FEDERAL COMMUNICATIONS COMMISSION

In re:)	File Nos. SAT-MOD-20031118-00333
Applications of)	SAT-AMD-20031118-00332
Mobile Satellite Ventures Subsidiary LLC)	SES-MOD-20031118-01879

REPLY

Technical Annex – January 5, 2005

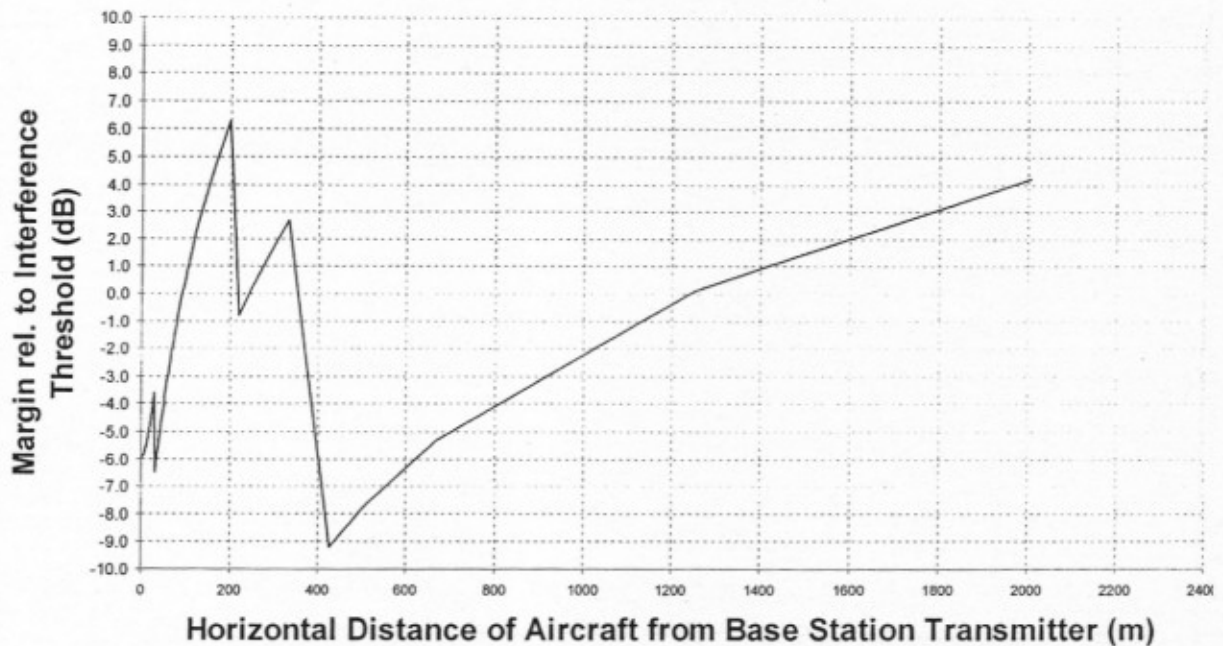
This shows there is a problem. The resulting interfering signal power is approximately 6 dB higher than the assumed overload threshold, and therefore the margin is negative 6 dB and not positive 6.87 dB. This represents a significant difference from MSV's results. In fact the altitude would need to be increased to 100 meters, using this same analysis with identical assumptions as MSV, to get zero interference margin, and 182 meters altitude to get the positive 6.87 dB margin that MSV indicates.⁶

Inmarsat is also unable to confirm MSV's assertion that "... as the horizontal distance between the aircraft and the ATC base station increases, the interference margin increases rapidly ...". Because of the nature of the proposed ATC base station antenna overhead gain suppression mask, the zenith situation is not the worst case in terms of interference margin, as Inmarsat has shown repeatedly in the past. The figure below shows the margin, relative to the assumed interference threshold of -50 dBm, for a range of horizontal distances, and using the same calculation methodology and assumptions as described above.⁷ Note that the margin is -6 dB at zero horizontal distance (as shown above), but the margin then becomes positive before then going negative again, reaching a worst-case of -9.2 dB at around 425 meters from the base station. Clearly this shows a result that is completely different from what MSV asserts. The significance of this is that the worst-case interference is not when the aircraft is immediately over

the ATC base station, but when it is some distance (425 meters for the particular assumptions used here) horizontally away from the base station.

Thus, MSV's analysis is not only incorrect in the calculated values, but also appears misleading in the way the results were presented in tabular form, where the true shape of the margin curve has effectively been concealed by appropriate choice of horizontal spacing values in the MSV table.

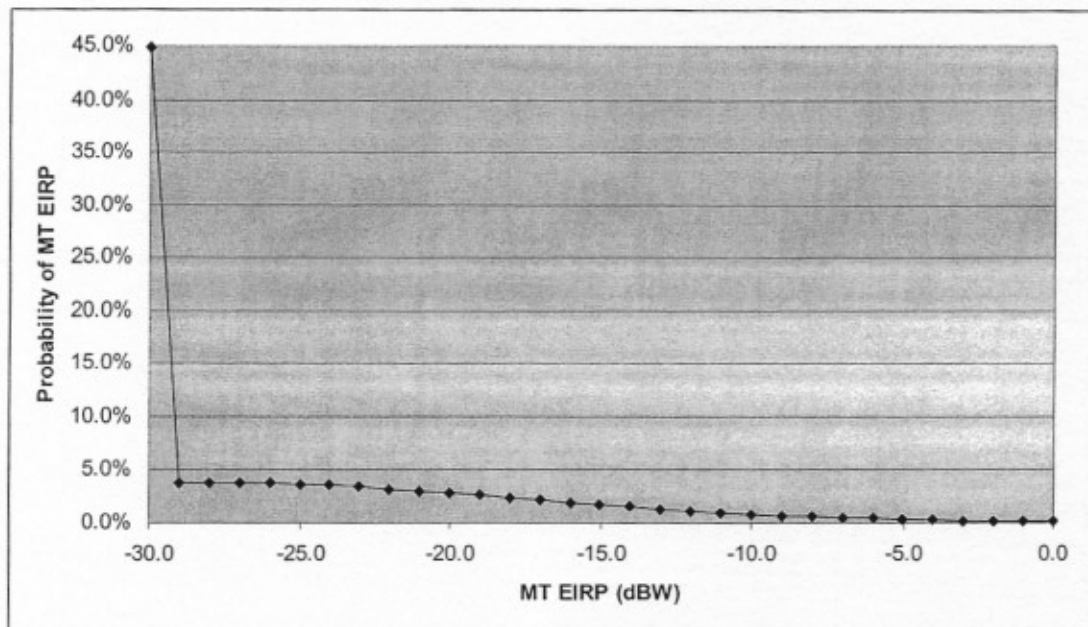
The EIRP at the cell edge (for 75% coverage) can be calculated to be -25 dBW from these parameters. Also, based on the characteristics of the cell it can be estimated that the average range taper is 3.6 dB. Hence, the MT EIRP required for 75% coverage within the cell is -28.6 dBW. Finally, based on the lognormal margin assumed, the standard deviation of the distribution can be calculated as 10.4 dB. With this information we can produce the distribution of EIRP levels in the cell. In doing this we take into account that the EIRP range is -30 dBW to 0 dBW. The EIRP distribution is shown in the following figure.

The average EIRP from this distribution is -17.5 dBW, i.e. 2.5 dB above -20 dBW.

It should be noted that in this example we have used the maximum EIRP of 0 dBW as specified by MSV in its link budget. If the maximum EIRP instead were -4 dBW (due to an average antenna gain of -4 dBi) there would be no significant difference. The minimum EIRP would become -34 dBW, the distribution above would be shifted by 4 dB and, to comply with the 20 dB power control margin, the required average EIRP would be -24 dBW. The main difference in this case is that MSV would be required to reduce the size of the cell to maintain the same link margin.
